Ignition Coil Housing Cracked (58/12)

This Technical Information replaces the TI dated July 7, 2014.

Concerns **Ignition coil**

Figure 2

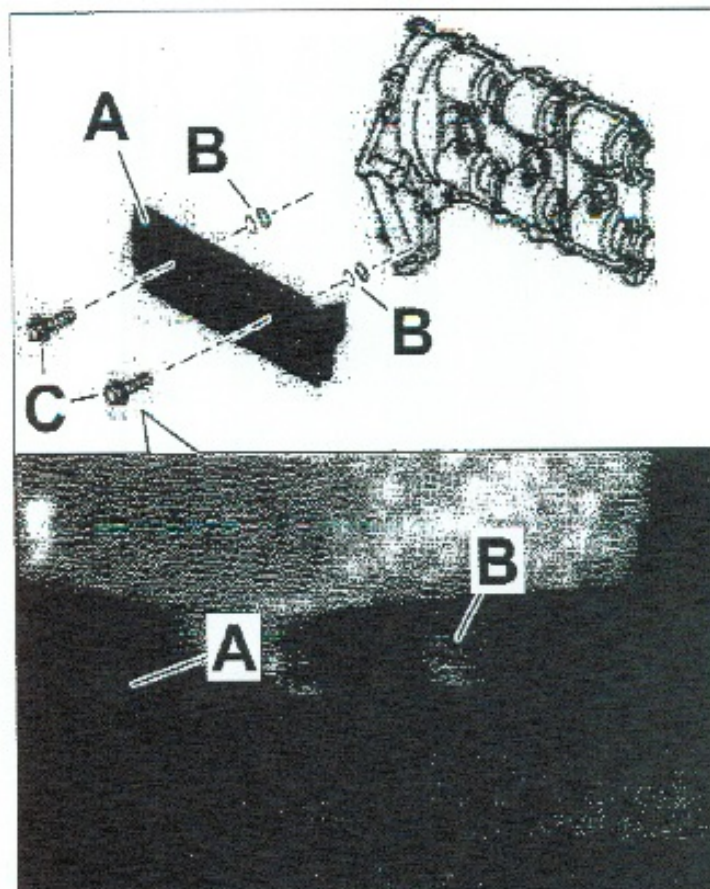
- 1 Replace ignition coils, see ⇒ *Workshop Manual '282019 Removing and installing ignition coil'*.
- 2 **When fitting the two heat shields** (already used; ⇒ *Figure 2-item A-*):

- two new, **longer screws** (Part No. 900.075.333.01, M6 x 25; ⇒ *Figure 2-item C-*) must be used.
- A **washer** (Part No. 999.025.220.30, **5 mm thick**; ⇒ *Figure 2-item B-*) must be used for each screw **and**
- a **washer** (Part No. 999.025.193.30, **3 mm thick**; ⇒ *Figure 2-item B-*) must also be used.

The two new washers (5 mm and 3 mm) must be fitted together between the heat shield and cylinder head ⇒ *Figure 2-item B-*) and will ensure a sufficient distance between the ignition coil and heat shield.
